Burlington, Ontario
Canada Centre for Inland Waters – CCIW
867 Lakeshore Road, Burlington, ON L7R-4A6

Library Renovation
Project Number R.061475.001

Addendum No. 3, dated 2014-01-29

ELECTRICAL ADDENDUM NO. E-01

Drawing no.: **SKE-E003X01**

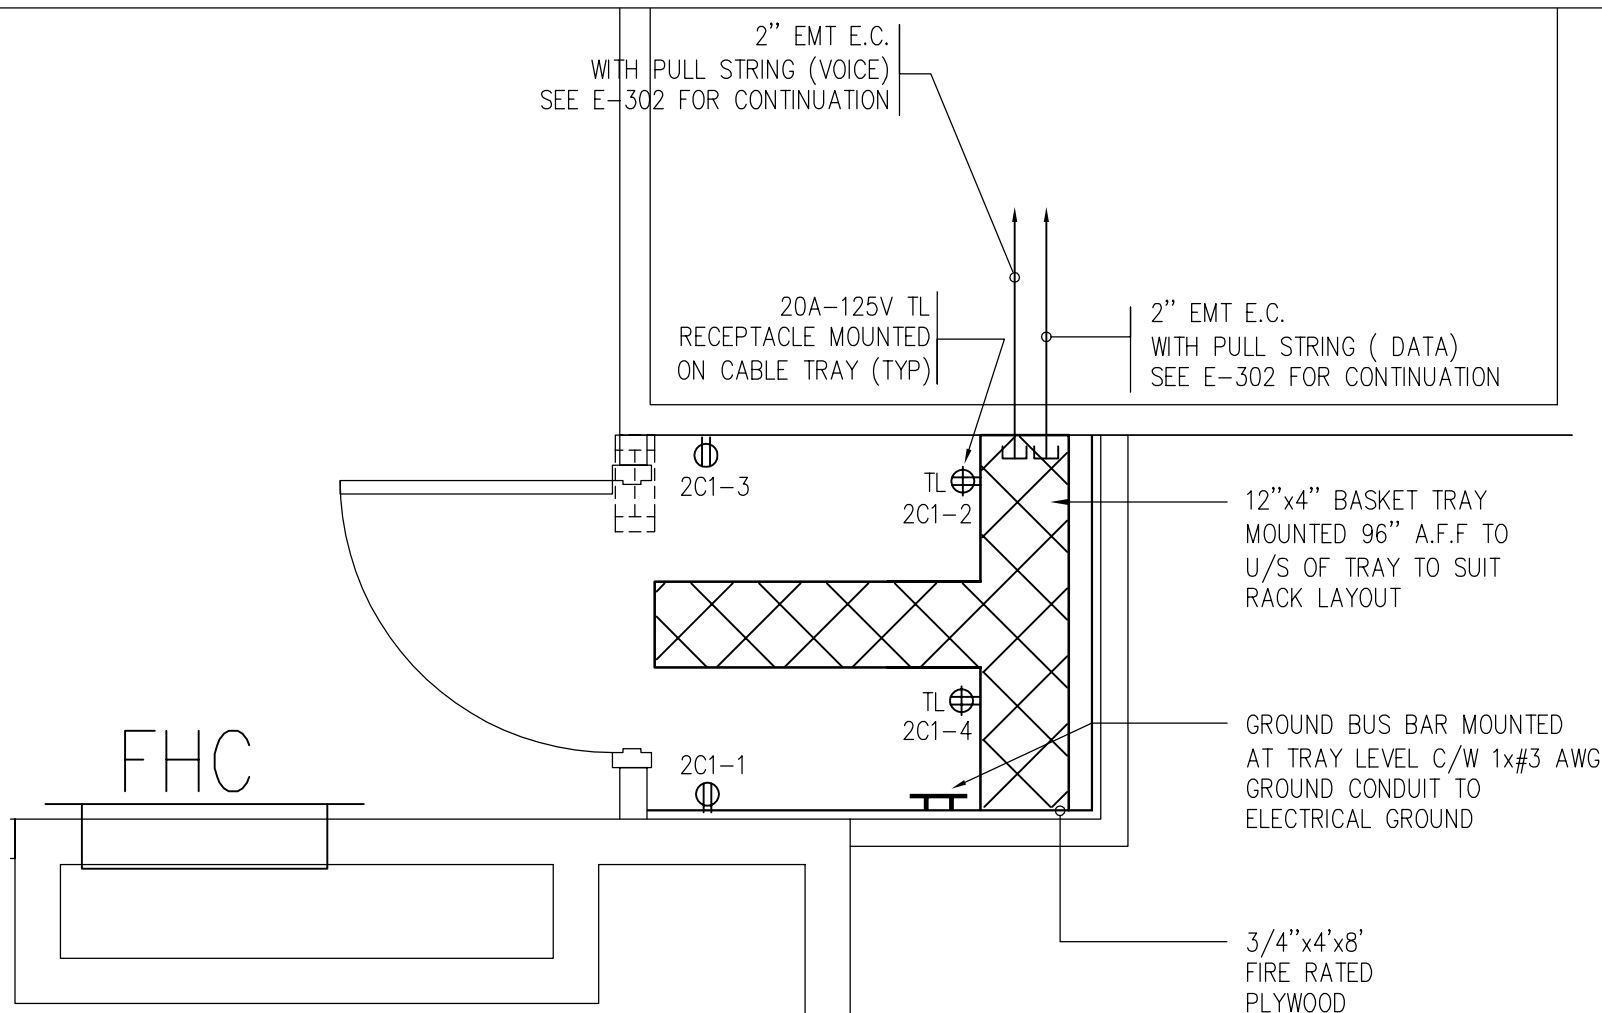
- 1.3.1 Add a detail of new Telecommunication room layout as shown as per SKE-003x1.

Drawing no.: **SKE-E302X01**

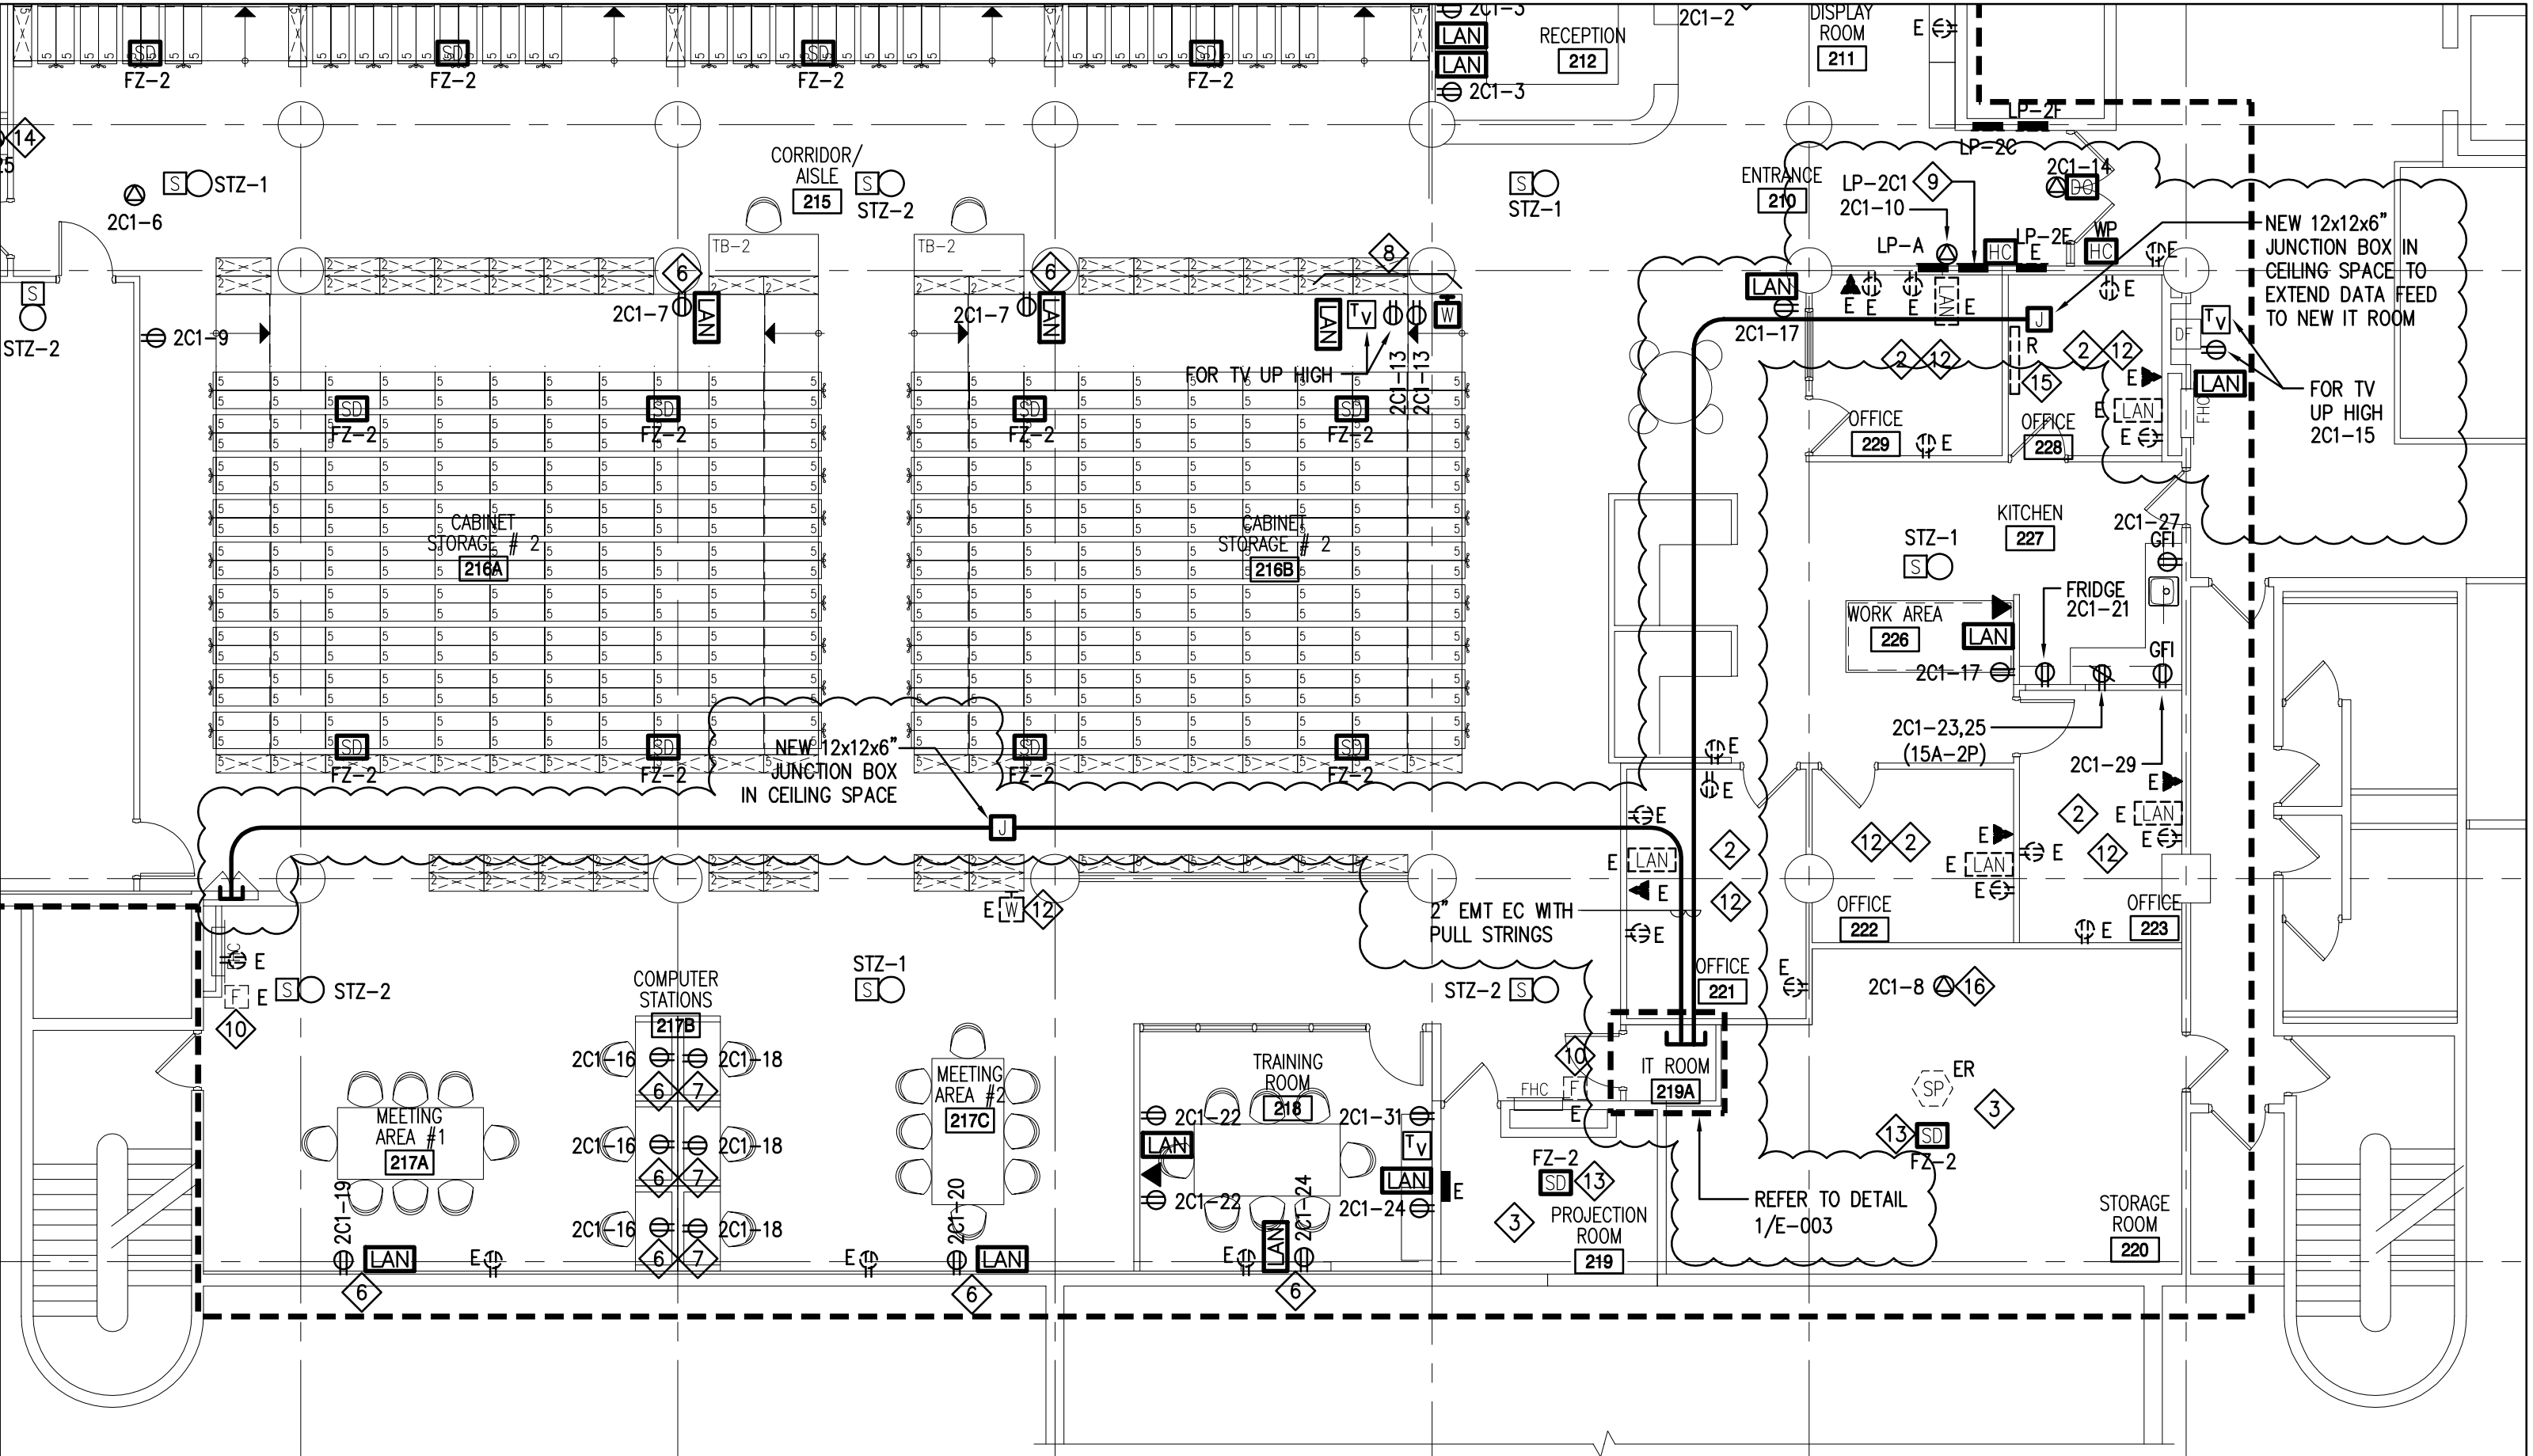
- 1.4.1 Revise the Telecommunication routing as indicated as per SKE-302x1.
- 1.4.2 Add relay panel LP-A located beside new panel LP-2C1 as indicated as per SKE-302x1.
- 1.4.3 Delete symbol "SP" from all Power & System plans.
